FURTHER INFORMATION FOR APPLICATION FOR CONSENT UNDER SECTION 36 TO CONSTRUCT AND OPERATE BERWICK BANK OFFSHORE WINDFARM, OFF THE COAST OF EAST LOTHIAN AND THE SCOTTISH BORDERS

Berwick Bank Offshore Wind Farm - Additional Information Application Representation by Caledonia Offshore Wind Farm

Figure 1. Berwick Bank shipping and navigation study area (a - left) and Berwick Bank project boundary and nearby SPAs, including Outer Firth of Forth and St Andrews Bay Complex SPA (b - right).

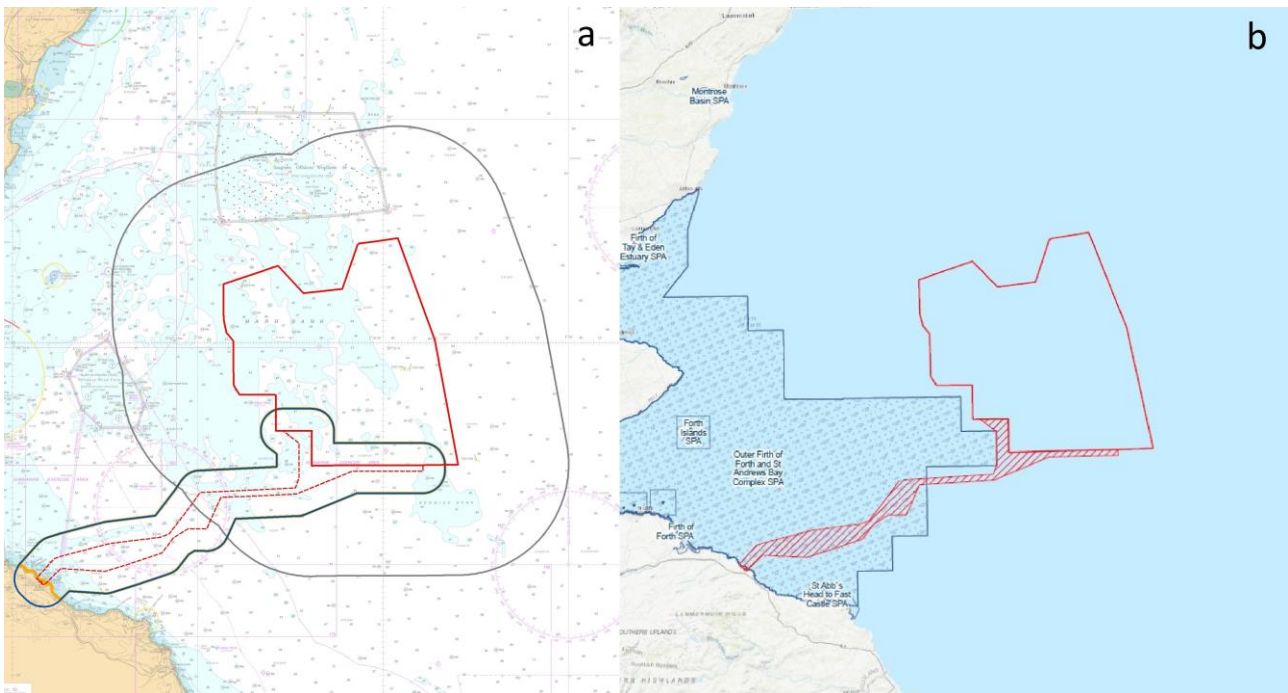
The existing vessel movements of 420-480 per month are located throughout the study area. No maps were provided within the additional information documents to illustrate spatially how these figures were derived. Please see Figure 1 below which we have produced to help explain the mismatch between the underpinning data provided for the shipping and navigation area and the SPA – this is based on the study area map provided within Chapter 13 Shipping and Navigation from the original application. The study area spans a 10 NM buffer around the development array and 2 NM around the export cable corridor (Figure 1a). As such the study area only partially overlaps with the Outer Firth of Forth and St Andrews Bay Complex SPA – please see Figure 1b which illustrates the location of the SPA relative to the development array area and export cable corridor. **No separate information has been presented on existing vessel movements within the SPA.** Thus, we are unclear if the existing vessel movements of 420-480 per month are wholly representative of the existing vessel movements within the SPA.

If the chosen port(s) or transit routes are within the SPA, the current information provided may not be representative of the full impact to the SPA. For instance, if the SPA has a lower amount of existing vessel movements compared to the study area, the additional traffic from the proposed development would represent a larger increase from the baseline. **In our assessment, we have assumed it is reflective of the level of traffic within the SPA, however we request confirmation or otherwise of this assumption.**
